Project	IEEE 802.16 Broadband Wireless Access Working Group < http://ieee802.org/16 >	
Title	Preamble sequence for supporting scalable FFT	
Date Submitted	2004-06-25	
Source(s)	Jiho Jang, Jeongheon Kim, Seungjoo Maeng, Panyuh Joo, Jaeho Jeon, Soonyoung Yoon Samsung Electronics Co., Ltd. Dong Suwon P.O.Box 105 416, Maetan-3dong, Yeongtong-gu, Suwon-city, Gyeonggi-do, Korea 442-600	jiho.jang@samsung.com jeongheon.kim@samsung.com sjmaeng@samsung.com panyuh@samsung.com jhjeon@samsung.com soon.young.yoon@samsung.com
Re:		
Abstract	Preamble sequences for FFT size other than 2048-FFT	
Purpose	Adopting of proposed method into P802.16e	
Notice	This document has been prepared to assist IEEE 802.16. It is offered as a basis for discussion and is not binding on the contributing individual(s) or organization(s). The material in this document is subject to change in form and content after further study. The contributor(s) reserve(s) the right to add, amend or withdraw material contained herein.

Preamble sequence for supporting scalable FFT

Figure aaa – Preamble sequence generator for 128-FFT

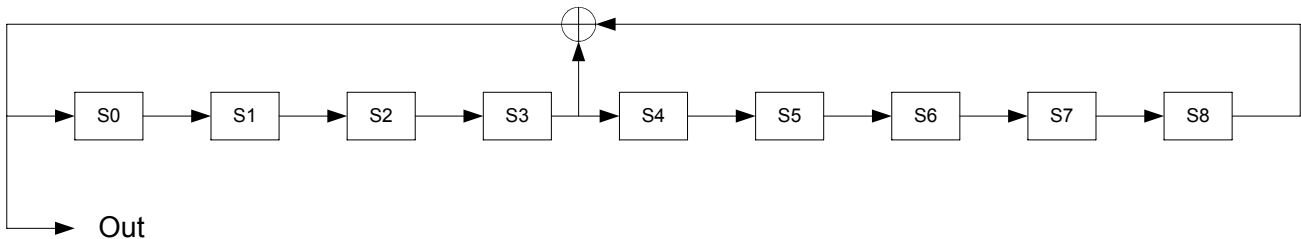
In IEEE 802.16e/D3, section 8.4.6.1.1 describes the preamble for scalable FFT as “For FFT size other than 2048-FFT, only the first k elements of table 307 shall used to modulate the DL preamble subcarriers, where k is the number of carriers.” However, the truncated preamble sequence from that of 2048-FFT may result in high PAPR (peak to average power ratio). We propose new preamble sequences for 128-FFT, 512-FFT, and 1024-FFT in this contribution, which have low PAPRs.

“For FFT size other than 2048-FFT, ~~only the first k elements of table 307 shall be used to modulate the DL preamble sub-carriers, where k is the number of carriers~~ use the following preamble sequences corresponding to the FFT size”

For the FFT size of 128-FFT, the preamble sequences can generated using the shift register structure in figure aaa where the initial state value are defined in table xxx. The first k elements of output sequence are used for a preamble, where k is the number of carriers.
